RE: **Lot 22 Block 9 Unit 18 SAD 228
6501 Picardia Ct. NW
Volcano Cliffs Subdivision
Grading and Drainage Plan
Engineers Stamp Date 11/3/2021 (D10D003I22)**

Based upon the information provided in your submittal received 11/4/2021, this plan is approved for Grading Permit.

DRAINAGE AND TRANSPORTATION INFORMATION SHEET (REV 6/2018)

ENGINEER'S SEAL	LOT 22 BLK 9 UN 18 VC 6501 PICARDIA PL	DRAWN BY DEM
DAVID SOULE NEW MEXICO REGISTERED PROFESSIONAL ENGINEER 11/3/21	GRADING AND DRAINAGE PLAN	DATE 11-3-21
DAVID SOULE P.E. #14522	Rio Grande Engineering P.O. BOX 53924 ALBUQUERQUE, NM 87199 (505) 321-9099	SHEET # C1
		JOB #

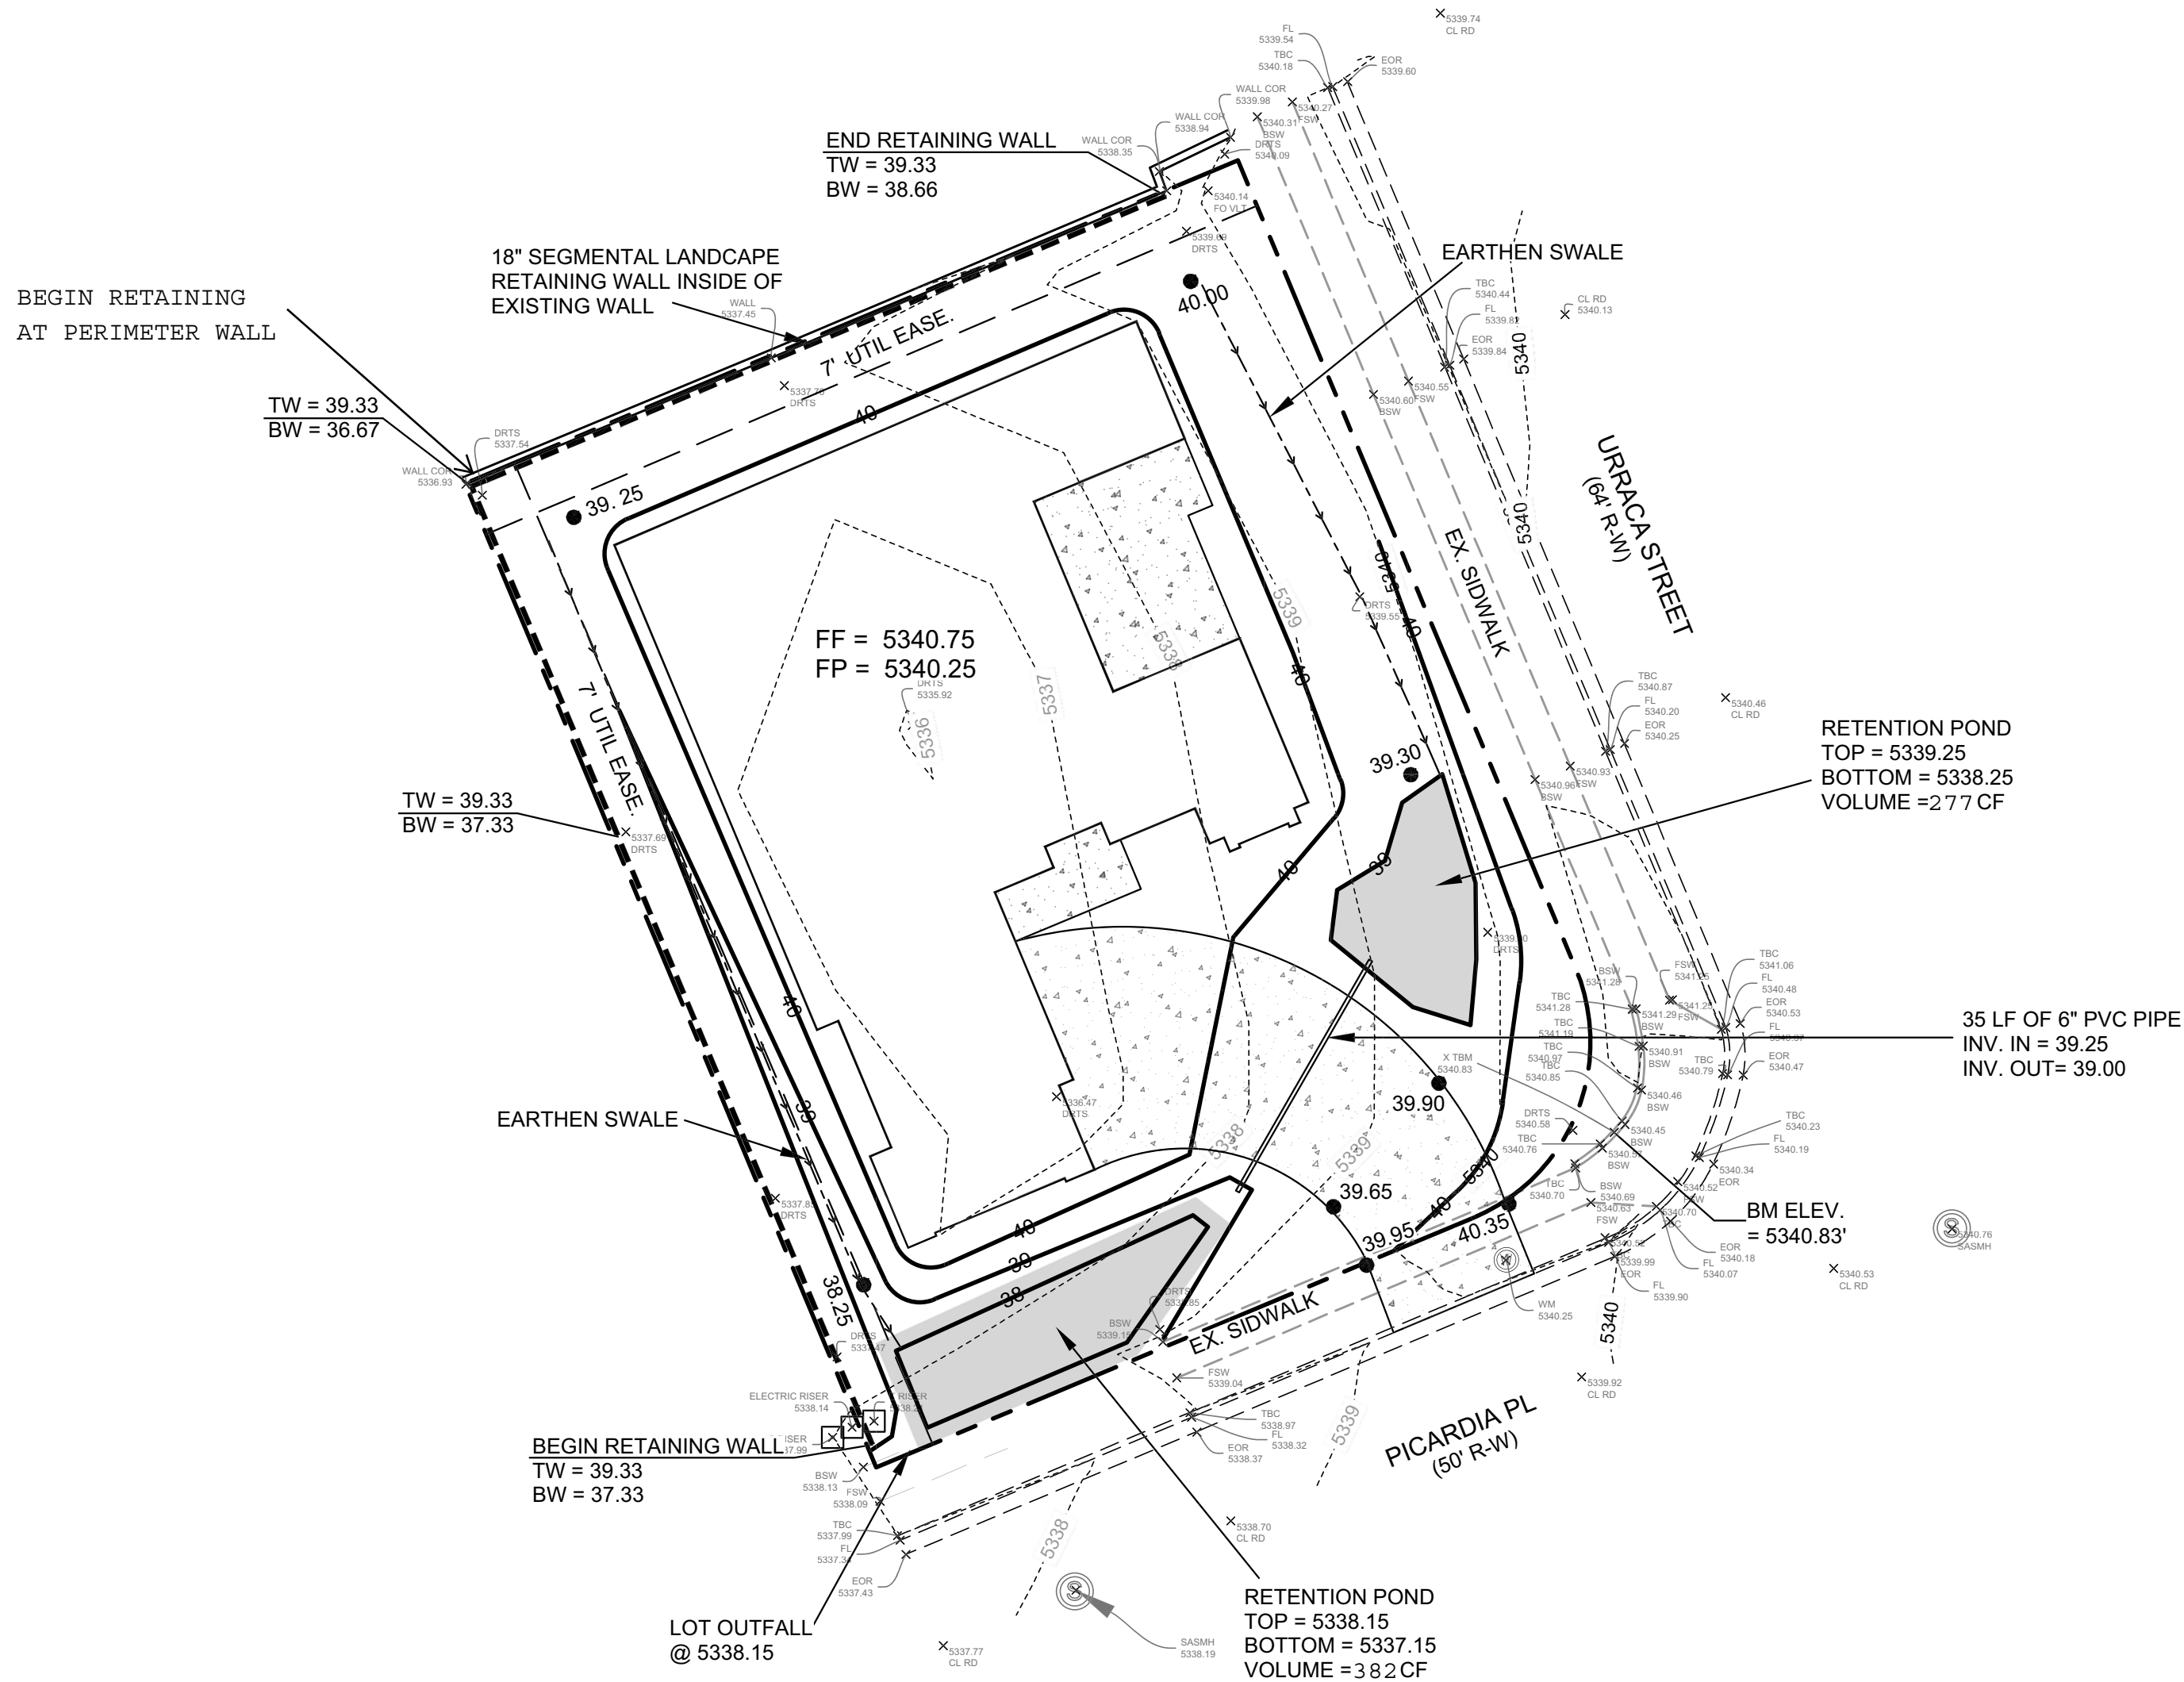
Prior to Building permit approval a Pad Certification will be required, provided by the Engineer or a registered Land Surveyor.

Advise the owner contractor not to use dirt as a ramp to climb the curb, use lumber or crusher fines for this purpose.

Reiterate to the Owner/Contractor that a separate permit for a garden/retaining wall must be obtained with the approved G&D plan and Pad Certification. Also, if a swimming pool is to be placed after this approval a new grading and drainage plan will need to be resubmitted showing the changes for the land treatments.

Prior to Certificate of Occupancy release, Engineer Certification per the DPM checklist is required.
